# UNITED STATES PATENT AND TRADEMARK OFFICE

APPLICATION NO.	FILING DATE	FIRST NAMED INVENTOR	ATTORNEY DOCKET NO.	CONFIRMATION NO.
10/708,928	04/01/2004	Kerry D. Hinson	60680-1780	2927

<b>Office Action Summary</b>	<b>Application No.</b> 10/708,928	<b>Applicant(s)</b> HINSON ET AL.	
	<b>Examiner</b> Jeffrey Sharp	<b>Art Unit</b> 3677

### **DETAILED ACTION**

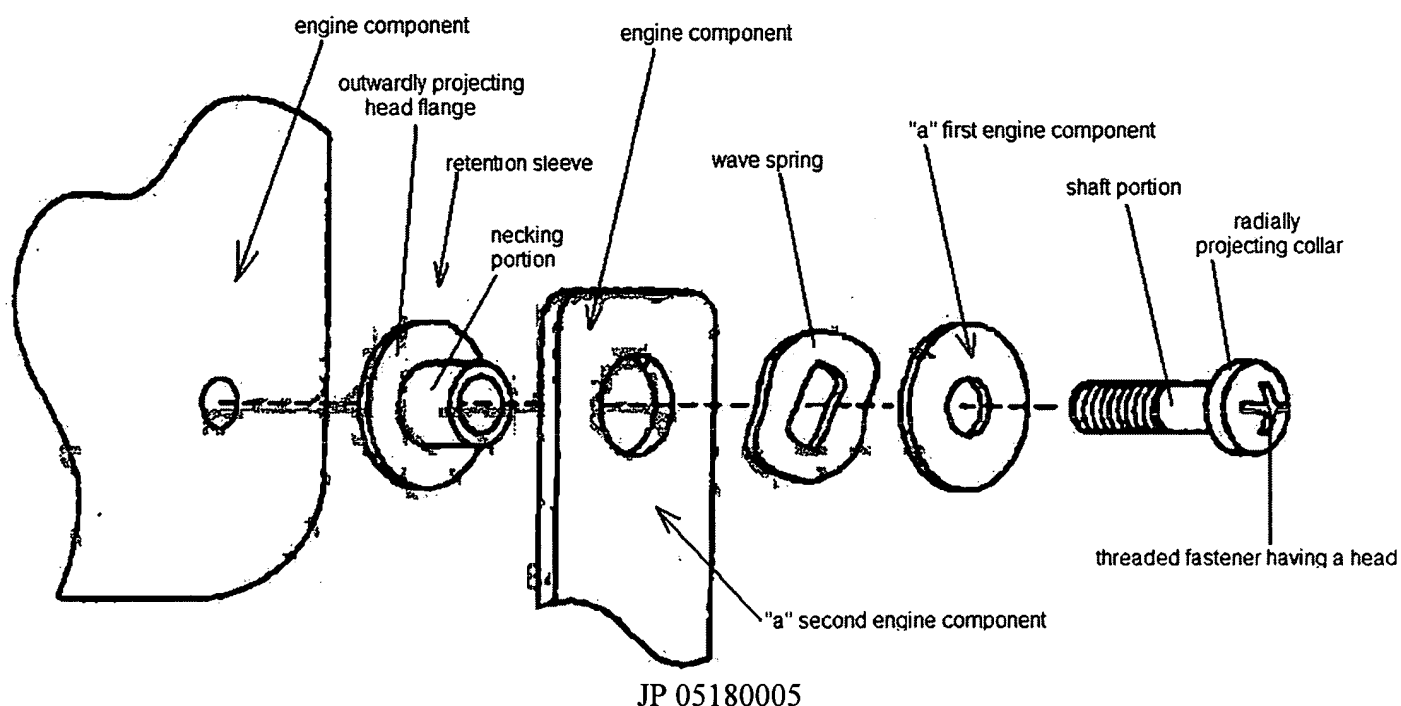
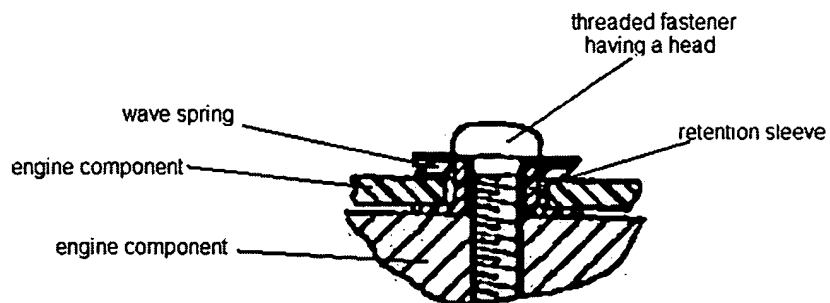
[7] Claims 1, 3-9, 11, 12, and 20 are rejected under 35 U.S.C. 102(b) as being clearly anticipated by, JP 05180005. See annotated drawing below. The fastener assembly taught by JP 05180005 "generally" forms a seal between engine components (3) and (10).

\*Retention sleeve of JP 05180005 extends at least partially through a first engine component, and a second engine component.

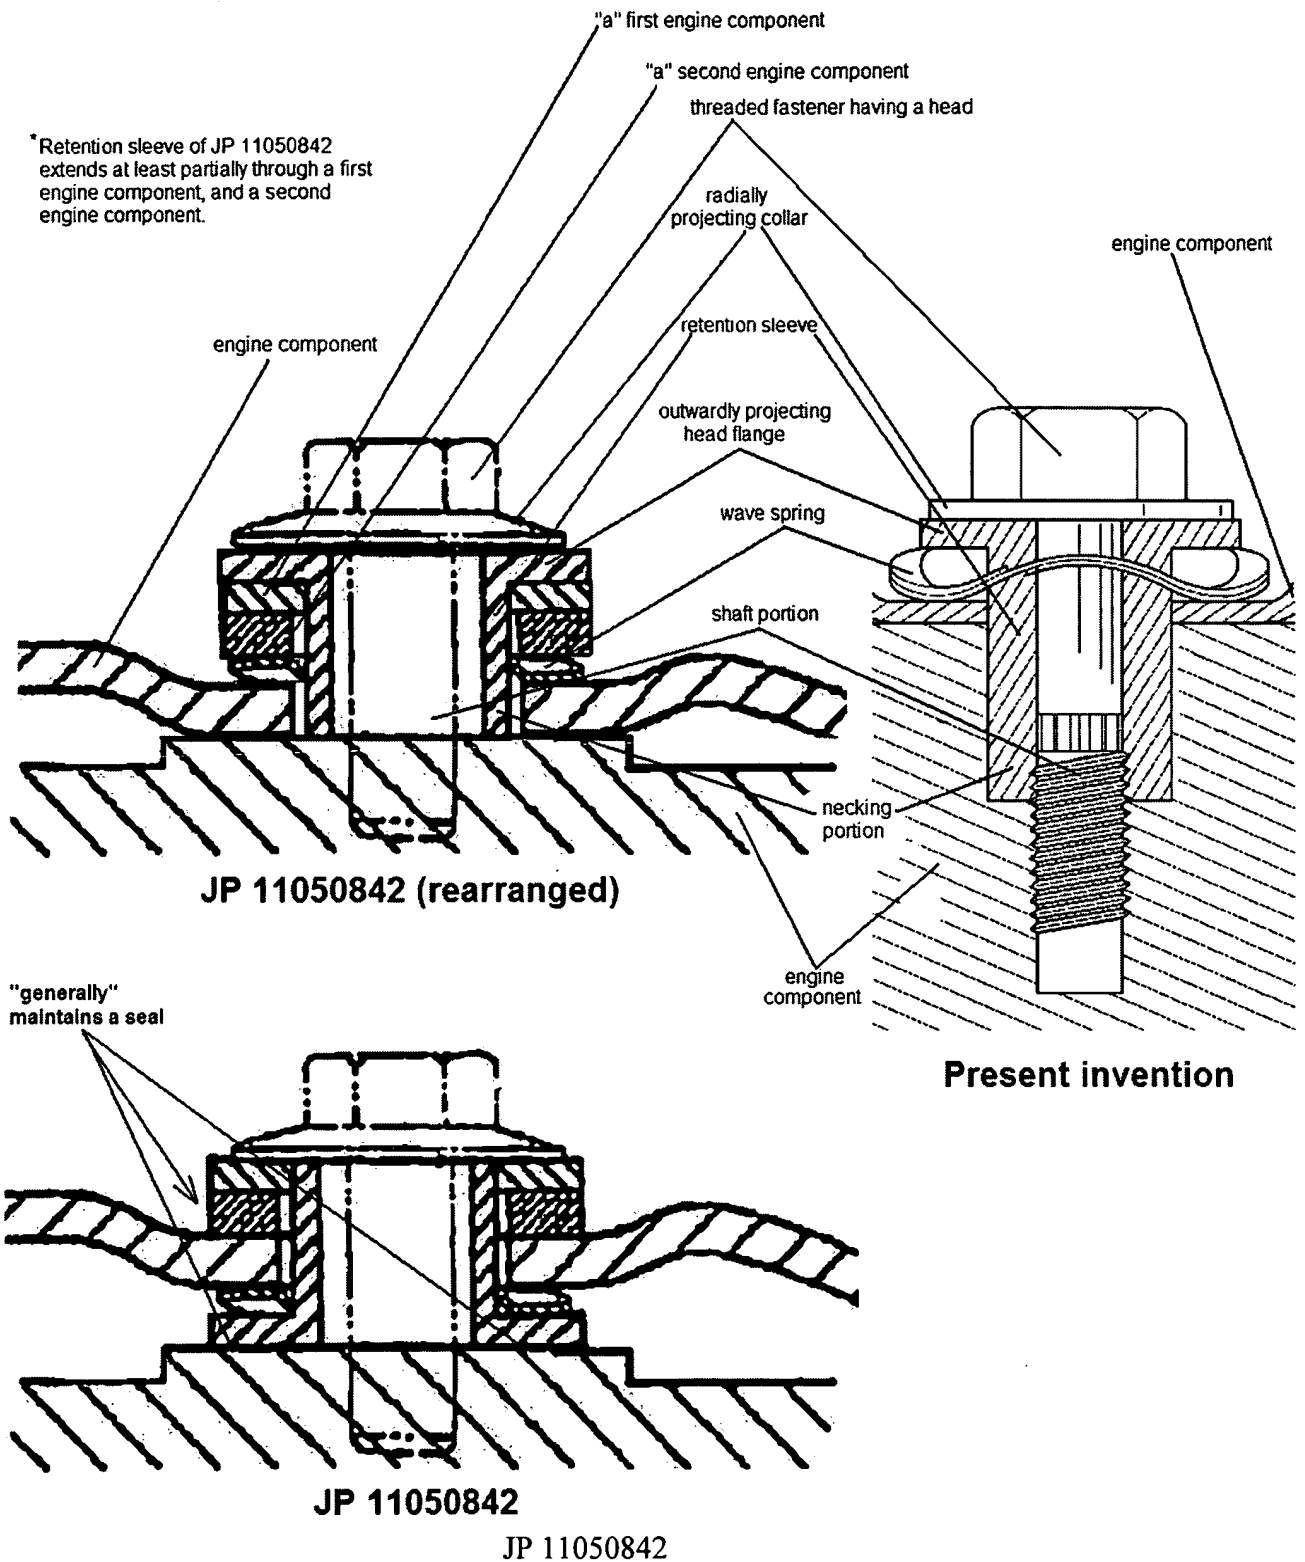
In short, JP 11050842 teaches a fastener assembly for connecting two components (1,2) of an engine, said assembly comprising:

a threaded fastener(s) (4) having a head portion with radially projecting collar (unlabeled),

a retention sleeve (3) disposed about said fastener having an outwardly projecting head flange (3b), and having a necking portion extending away from the flange portion which is of smaller diameter than said projecting head flange; said retention sleeve extending at least partially into an aperture formed in a first engine component (1,3a,5), and

a wave spring(s) (6) disposed about the retention sleeve which has an inner diameter slightly larger than an outer diameter of the retention sleeve, said wave spring abutting the retention sleeve such that it is "selectively" prevented from being fully compressed (shown clearly in drawing);

wherein the fastener assembly "generally" maintains a seal between said two components (1,2).

\*Pertinent to claims 11 and 12, Figure 2 of JP 11050842 shows multiple fasteners and wave springs to acoustically decouple two engine components.

Schmidt, Jr. US-5,711,711

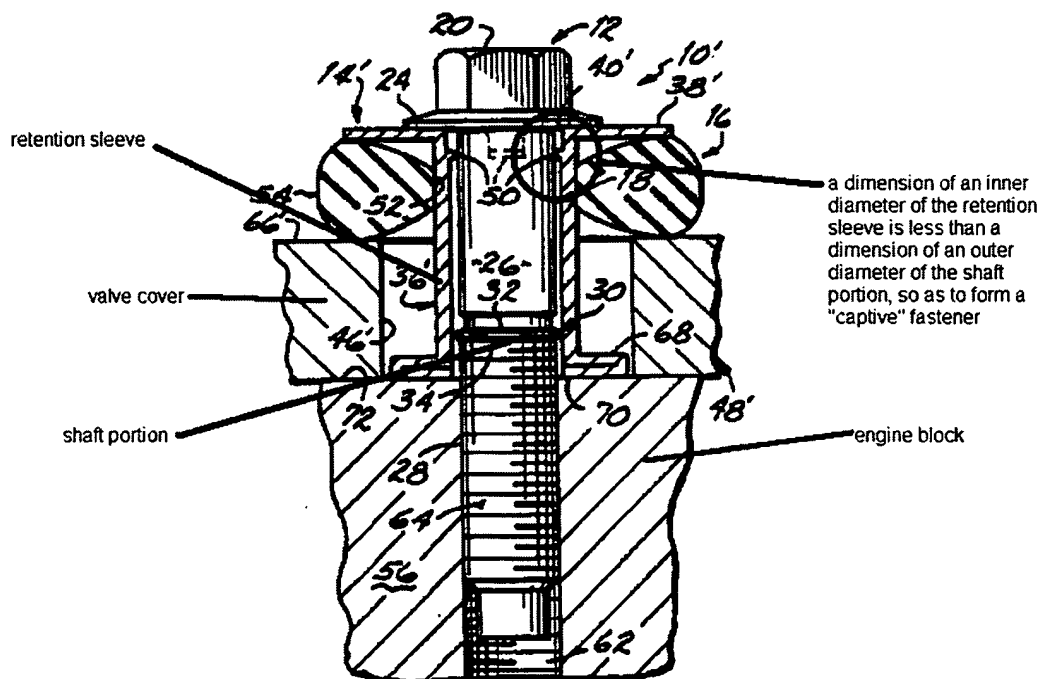
Schmidt, Jr. suggests a fastener assembly for mounting an upper workpiece to a lower workpiece, and mentions an application where it could be advantageously used to mount a valve cover to an engine block. This would suggest to one of ordinary skill that fastener assemblies, in general, could be used to join valve covers and engine blocks as an *intended use* of the fastener assembly.

Schmidt, Jr. also suggests a retention sleeve having an inner diameter smaller than an outer diameter of the threaded fastener shaft, in order to keep the two parts from separation. One of ordinary skill in the art would further appreciate that this fastener "sub-assembly" may also help reduce manufacturing costs, reduce assembly time, and prevent inadvertent loss of the bolt(s) when the valve cover is taken off. It has been held to be within the general skill of a worker in the art to make plural parts unitary as a matter of obvious choice. *In re Larson*, 144 USPQ 347 (CCPA 1965); *In re Lockart*, 90 USPQ 214 (CCPA 1951).
